Subject: 1014 Blue Astser Trail sidewalk extension at River Birch Road

REF: Extension of sidewalk along south side of River Birch Road onto the MCPSD site

REF: Street and sidewalk development at west end of River Birch Road and the MCPSD site

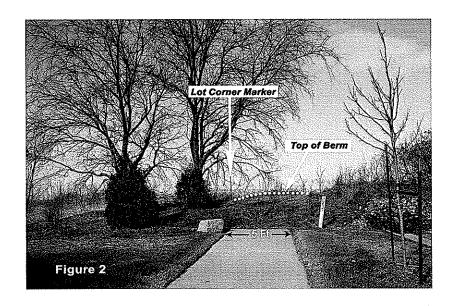
Extension of the sidewalk as River Birch Road is extended westward means cutting through the berm (Figure 2). The cut will produce a steep slope along the edge of the lot that will be difficult to maintain. Soil is likely to erode onto the sidewalk because of the steep grade adjacent to the sidewalk. Such soil erosion could damage the trees on the lot and negatively impact pedestrian traffic.

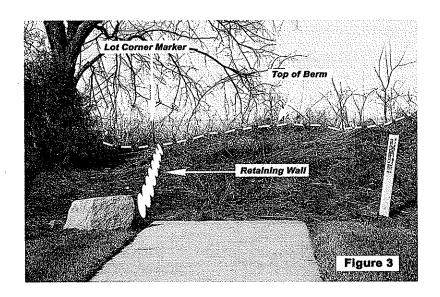
A retaining wall constructed along the south edge of the sidewalk (Figure 3) will hold the soil in place and maintain the grade along the back corner of Lot 418. The lot corner marker approximately 11 inches from the south edge of the sidewalk providing some space between the walk and the lot line for a wall. The owner of Lot 418 is willing to allow the wall to extend onto the edge of the lot so the retaining wall does not interfere with the sidewalk.

The drip line of the large deciduous tree straddling the property line (upper left in Figure 3) extends over the sidewalk. The owner of Lot 418 recognizes the low probability that the tree will survive after the sidewalk cut and expects that the tree will be cut down and that debris will be removed as part the sidewalk extension. Cost of removal of the tree is to be borne by MCPSD. The owner also requests that every effort be made to minimize disturbing the soil near the Arborvitae (evergreens) planted at the northwest corner of Lot 418. The owner requests that any backfilling behind the stonewall be done with topsoil and at the expense of the MCPSD.

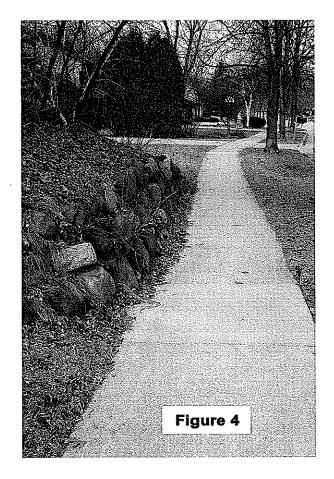
Figure 4 shows a boulder retaining wall in a setting similar to that along the west end of River Birch Road. The example wall is located between 7417 and 7421 Farmington Way, west of Westfield Road on Madison's far west side. Although the bank of soil retained along Farmington Way is higher than at River Birch, the approach is the one desired for use along River Birch Road.

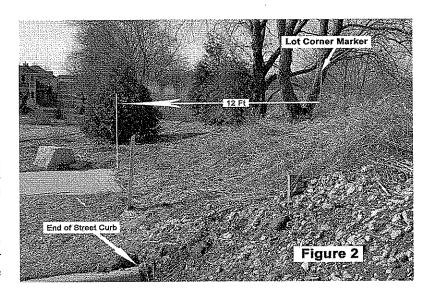
Figure 2 shows where the street curb and sidewalk end relative to the Lot Corner Marker, the point where Lot 418 and the MCPSD property abut. The twelve-foot gap between the back property line and paving coincides with a twelve-foot wide utility easement extending along the back of Lot 418. The yellow utility marker at the left center of the image is at the edge of the easement.
